Proposal for Optimization of Alternative Header Version 1

IEEE 1722b Task Group

September 2022

Current Proposed Alternative Header

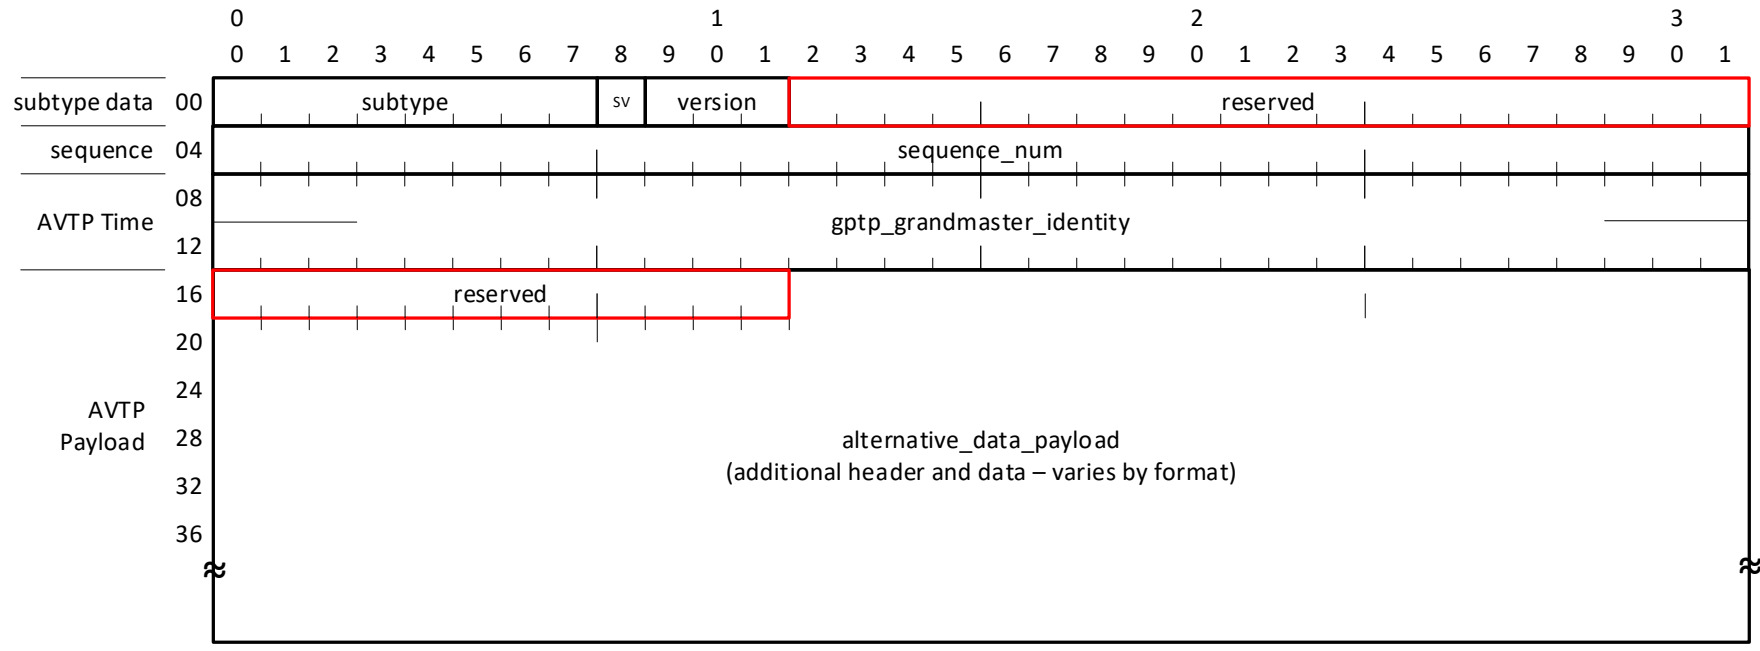
- We spare a full quadlet as „reserved“ to preserve alignment and cohesion of existing alternative data payload
- Is cohesion even needed?

Current Usage of subtype data Quadlet

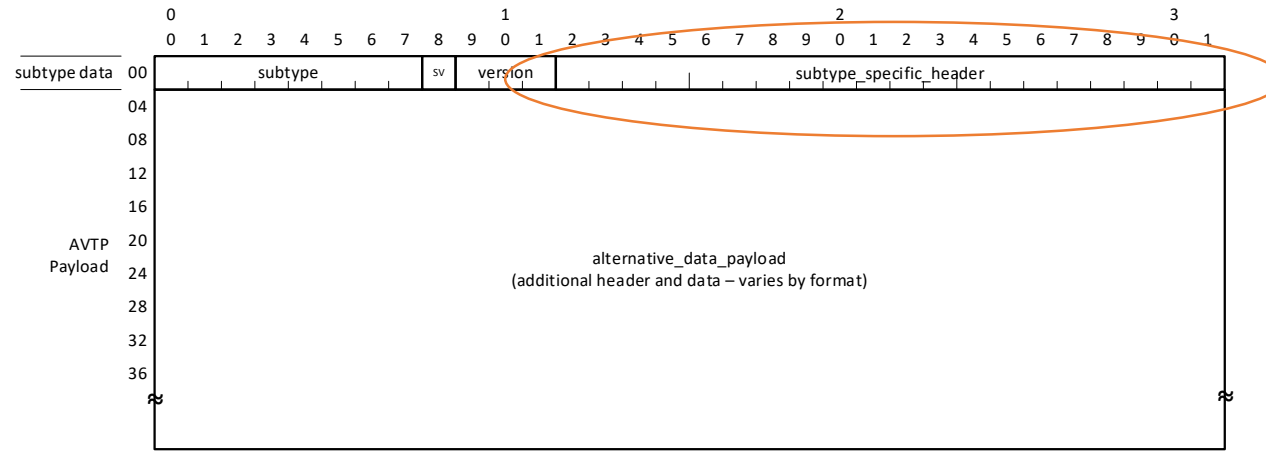
- All existing subtypes making use of the alternative header version 0 format today can be modeled as shown in the diagram: All subtype-specific fields within the first quadlet could be described as “subtype_specific_header” without colliding with any existing use and without “cutting” any existing fields into fragments
- **alternative_data_payload** might or might not contain additional subtype-specific header information, no change to today.
- I do *not* suggest to change the existing version 0 definition.

Proposal for Alternative Header Version 1

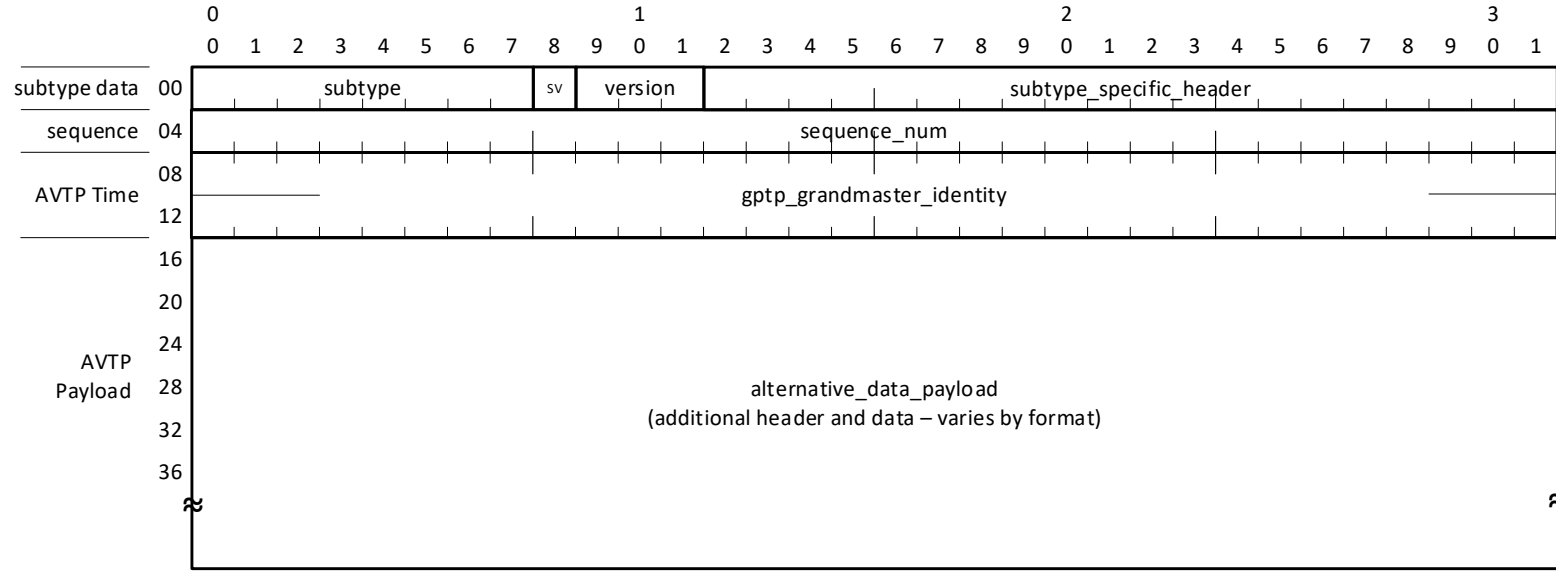
- For version 1, define a new placeholder field called “**subtype_specific_header**” in 4.4.6
- Eliminate “reserved” quadlet
- For each subtype using the alternative header format, make **subtype_specific_header** contain the existing fields at that location, preserving layout of the first quadlet
- Insert extended **sequence_num** and **gtp_grandmaster_identity** afterwards
- Then continue with the alternative payload, potentially including further subtype-specific header fields

Example for CRF Version 1 PDU Layout

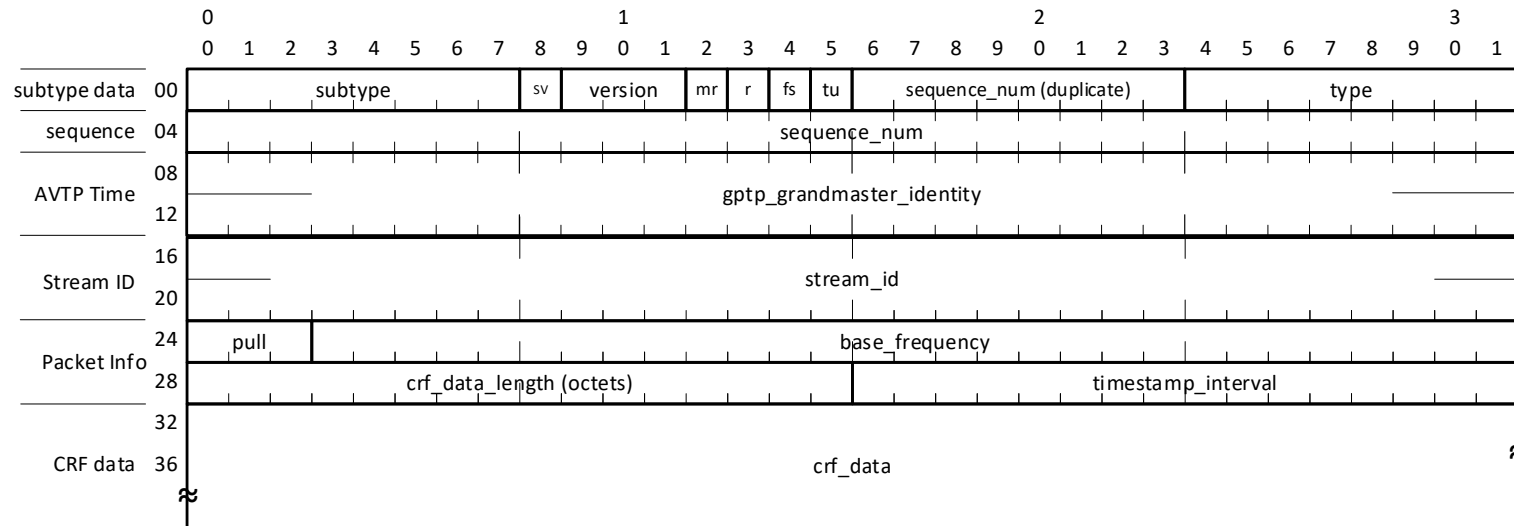
- Text would state that **subtype_specific_header** contains the **mr**, **fs**, **tu**, **sequence_num (duplicate)** and **type** fields.
- Layout stays the same as for version 0, except for the inserted wide **sequence_num** and **gtp_grandmaster_identity**
 - Potentially simplifies HW-accelerated processing
- Debatable if “**sequence_num (duplicate)**” is actually needed
 - In any case, would require clarification that this is a duplicate of the least significant eight bits of the wide **sequence_num**, and the fields should have unique names
